Water & Natural Features Gray Road Allowance

Close-up Location Drawing provided by Applicant Hwy 35 and Gray Road Allowance in reply to OEB interrogatory, January 21st, 2015.

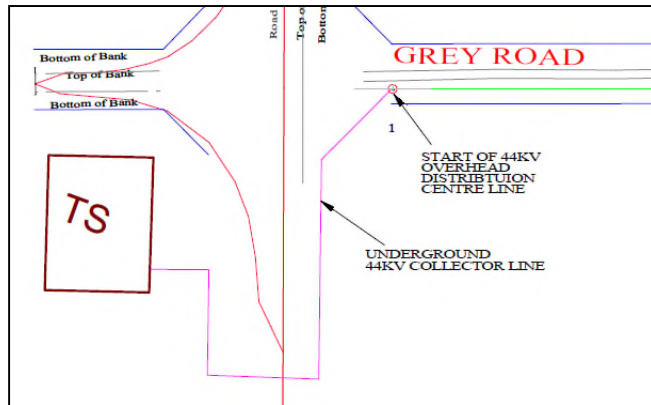
Water features are not provided in maps by the Applicant in this OEB application. The purple square denotes TS. The thick red line denotes the distribution line along the road allowance Gray Road. The thinner red broken line is meant to denote the 120 m natural heritage buffer zone; areas within the zone that the Applicant now intends to clear of all vegetation.

Within a hundred metres of Gray Road from Hwy 35 eastward, the water table is at the ground level. There is a permanent seep within the road allowance that the Applicant did not account for in its REA application or in this application before the board. This seep within the road allowance expands and contracts but never goes dry even in the time of severe drought.

Close-up of the same area from a map in Sumac Ridge Water Assessment.

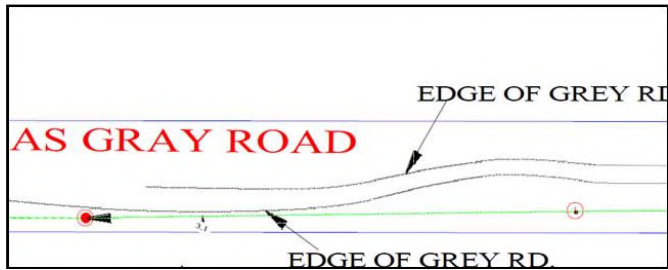
The pond along Gray Road that provides stopover habitat for waterfowl.
